Access Compliance Report Public Rights-of-Way (Curb Ramps)

Intersection ID: N/AMain Street:ENDHAVEN_VILLAGE_DRCross Street:ENDHAVEN_LNLocation:NEADA ID: B89467CE95F1Ramp Type:Directional1Initial Pass/Fail:FailOverall Compliance:NoSeverity Score:1.25

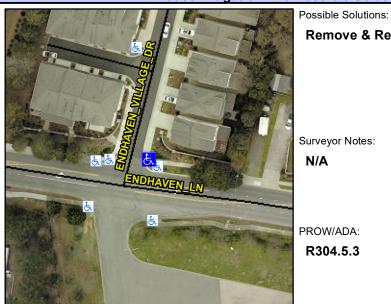
Comp	liance Description	Data	Comp	liance Description	Data
p.	N/A	Ramp Length (in)	73.0	N/A	Grade Break?	N/A
	Yes	Ramp Width (in)	60.0	N/A	Grade Break Slope (%)	0.0
	Yes	Ramp Slope (%)	7.4	N/A	Grade Break XSlope (%)	0.0
	No	Ramp XSlope (%)	3.8			
	N/A	Flare Type LT	N/A	N/A	Flare Type RT	N/A
	N/A	Flare Slope LT (%)	N/A	N/A	Flare Slope RT (%)	0.0
	N/A	Flare Traversable LT?	N/A	N/A	Flare Traversable RT?	N/A
	N/A	Landing Length (in)	0.0	N/A	DWS Provided?	N/A
	N/A	Landing Width (in)	0.0	N/A	DWS Contrast?	N/A
	N/A	Landing Slope (%)	0.0	N/A	DWS Length (in)	N/A
	N/A	Landing X Slope (%)	0.0	N/A	DWS Full Width?	N/A
	N/A	Landing Curb? (Y/N)	N/A	N/A	DWS Offset LT (in)	N/A
	N/A	Shared Landing?	N/A	N/A	DWS Offset RT (in)	N/A
	N/A	Gutter Ponding?	0.0	N/A	Gutter Slope (%)	N/A
	N/A	Gutter Lip Ht (in)	0.0	N/A	Gutter X Slope (%)	N/A
	N/A	Painted X Walk1?	No		Road Slope (%)	3.4
		X Walk 1 Direction	To SW		Road X Slope (%)	1.3

Remove & Replace Entire Ramp.							
Surveyor Notes:							
N/A							
PROW/ADA:							
R304.5.3
